**King's Mark Resource Conservation & Development Area, Inc.
Paddock Ridge Subdivision**

Environmental Review Team Report

For the
Inland Wetlands Commission
Naugatuck, Connecticut

April 2010

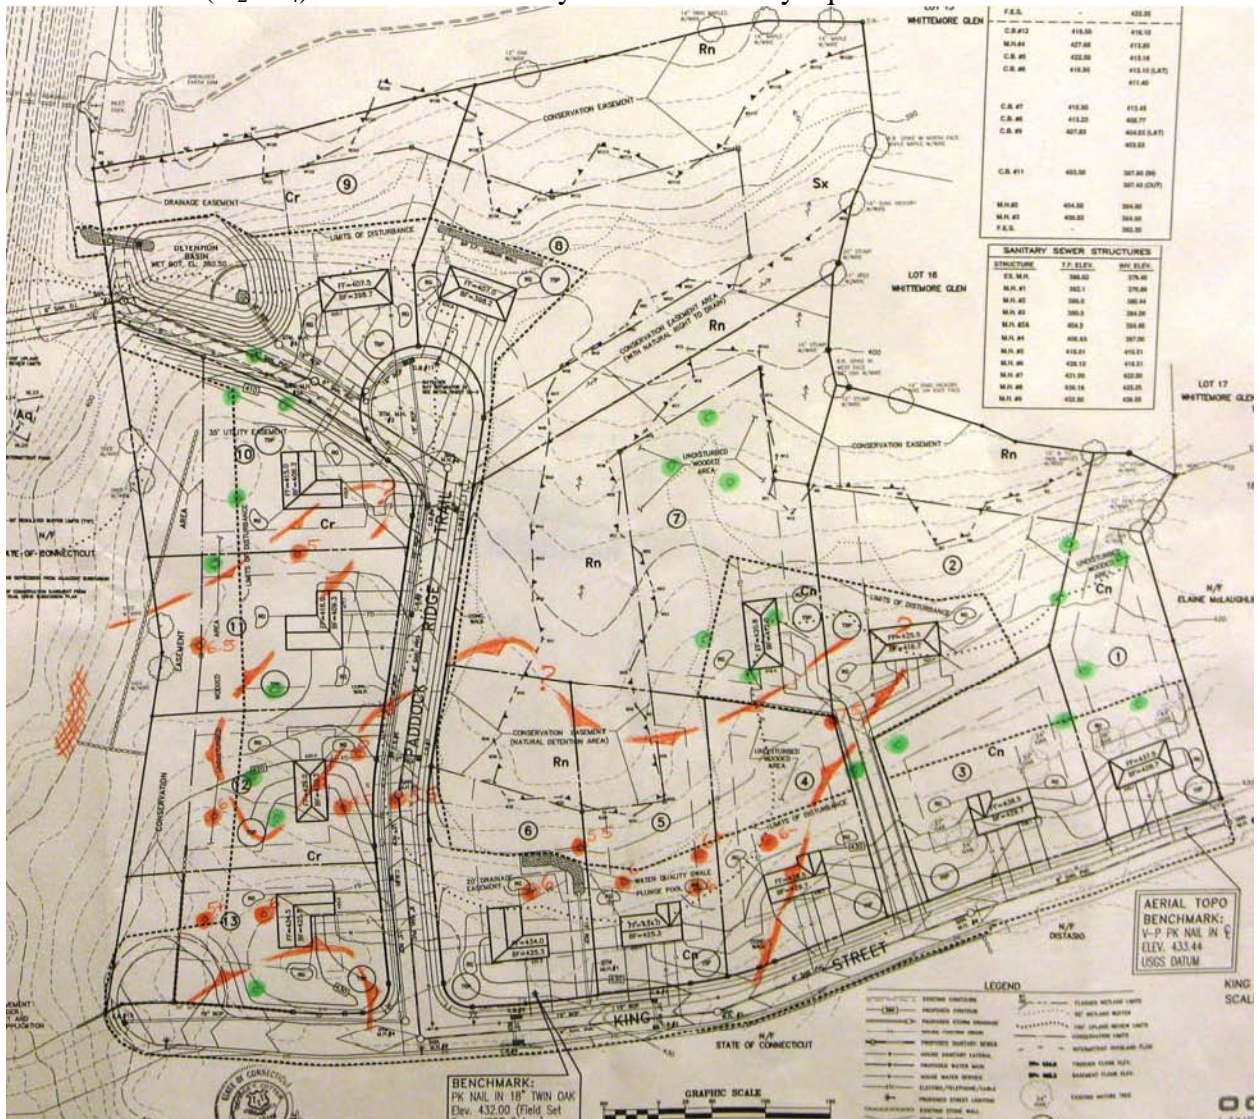
considered reliable; shallow values (1994) are considered to have encountered boulders. Figure 2 shows areas with shallow bedrock (ledge) beneath lots 4-6 and 10-13. In addition, an outcropping of ledge was observed on the south slope on state property opposite Lots 11 and 12. Bedrock is mostly biotite plagioclase gneiss. It will be encountered in some areas when digging foundations and utility (especially sanitary) trenches. The Waterbury Gneiss is “hard” and will likely require blasting. The spoils most likely can be used for back filling, but should be checked for the presence of sulfide minerals. Sulfide minerals leach out of the broken rock producing iron oxide (rust) and acidic leachate (H_2SO_4) and could adversely affect the nearby aquatic habitat.

EXHIBIT #4
ALTERNATE CONFIG. / E.P.'S

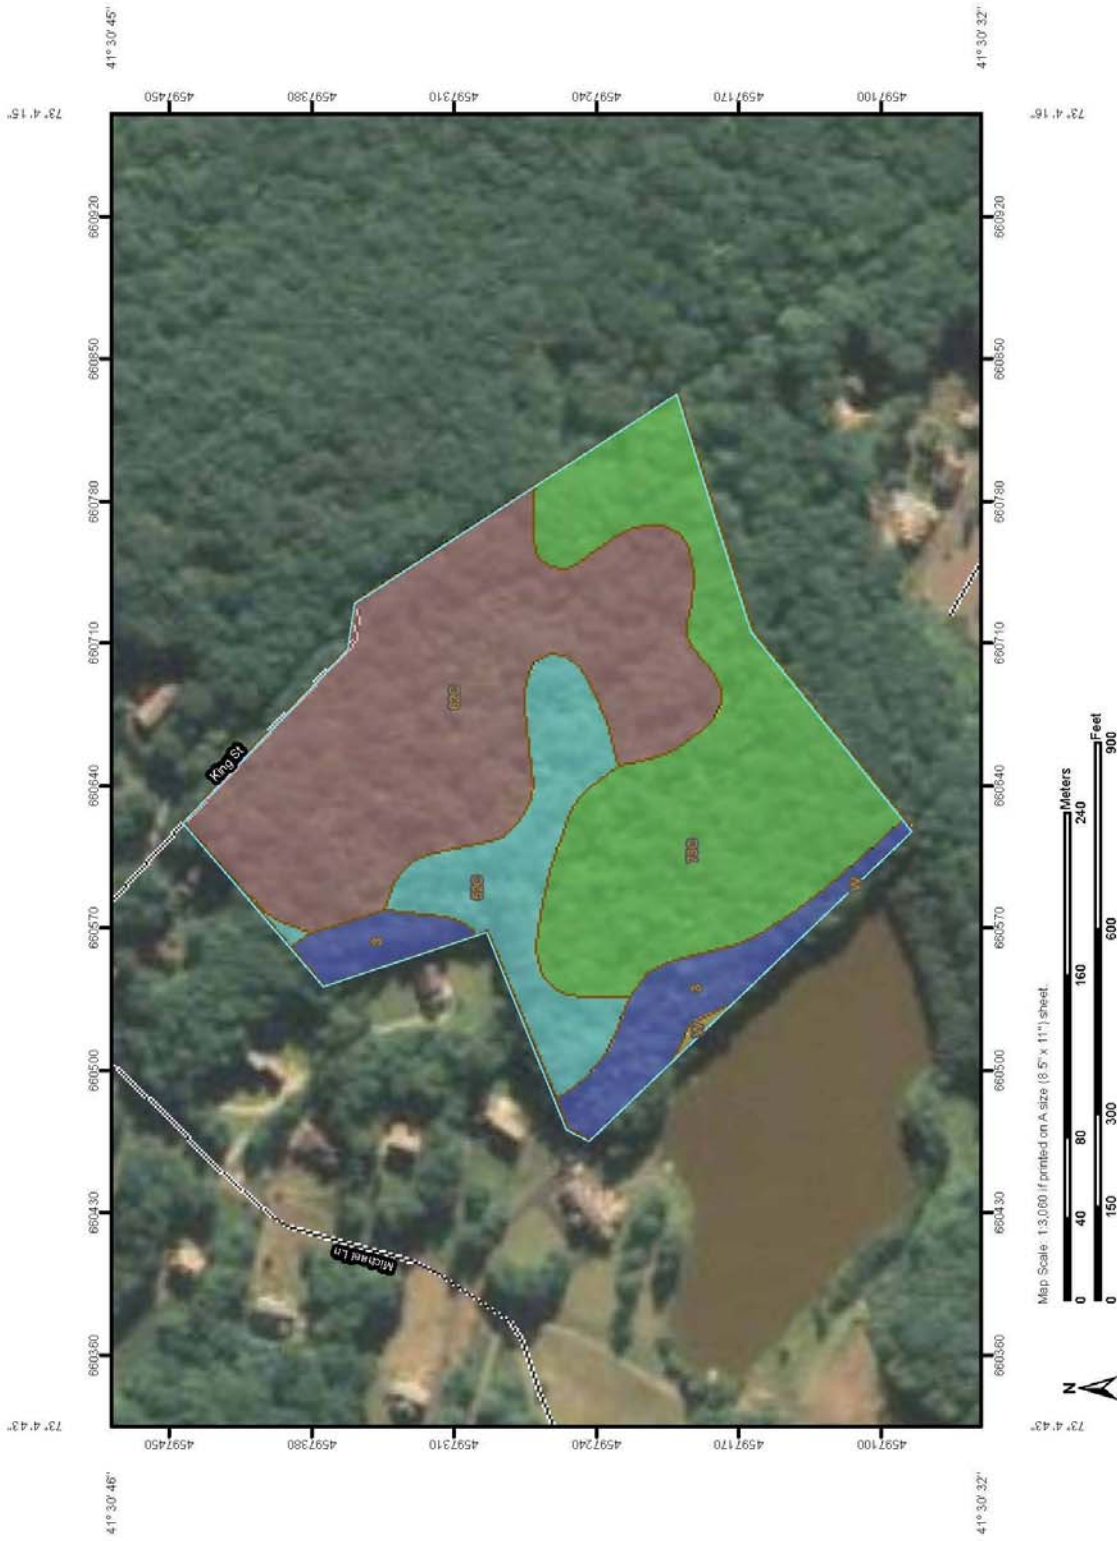
Limit disturbance of CrC Soil Type - Highly Erodible Land. (HEL)

1. **Proposed Detention Basin** - Relocate and redesign the proposed sedimentation basin to Lot #8. Configuration should be a Multi-celled basin with increased time of travel through the basin with micro-pools and wetland plantings to provide nutrient uptake and greater raw water renovation prior to discharge. Discharge should be through a Level Spreader designed to a minimum 25-year design criteria and the effluent reintroduced to the area between wetland flagging #48 thru 51.

2. **Lot #8** – Consider eliminating the dwelling on Lot #8 to accommodate multi-celled basin.
3. **Lot #9** – Shift dwelling and driveway closer to the proposed ROW for the sanitary sewer line to limit disturbance of steep slopes and reduce the risk of erosion and siltation of sensitive down slope environments. This would provide greater buffering of the pond from potential impacts.

4. **Lots # 2 & #7** – Consider eliminating these back lots to reduce unnecessary fragmentation of upland habitat that is crucial to the survival of amphibians in the adjoining wetlands, watercourses and Barbers Pond.
